Intel[®] 82371AB PIIX4, Intel[®] 82371EB PIIX4E, Intel[®] 82371MB PIIX4M

Specification Update

January 2002

Document Number: [297738-017](#)

TD CONTROL AND STATUS (DWORD 1: 04-07h)

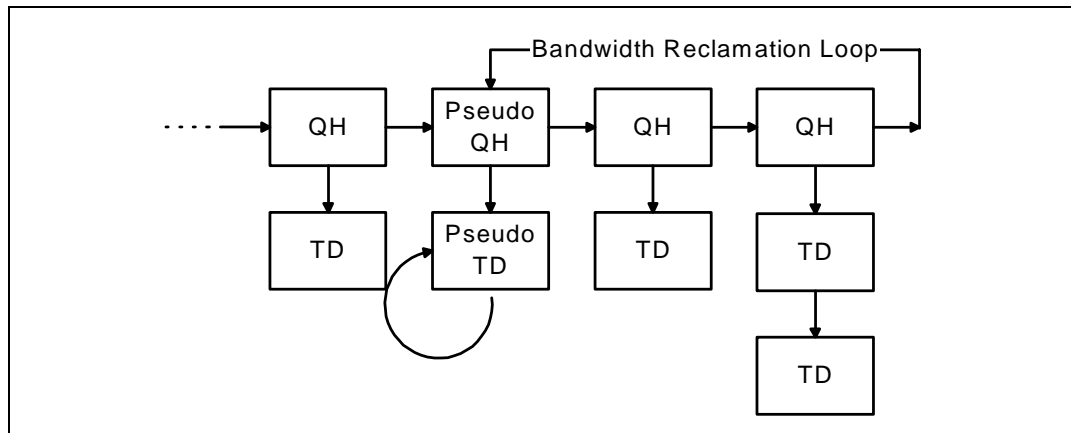
The Active status bit (bit 23) must be left unset at 0 indicating that the PIIX4/PIIX4E/PIIX4M should not execute this TD.

QUEUE HEAD LINK POINTER (DWORD 0: 00-03h)

The Queue Head Link Pointer (QHLP=bits [31:4]) must be set to point to the pseudo TD.
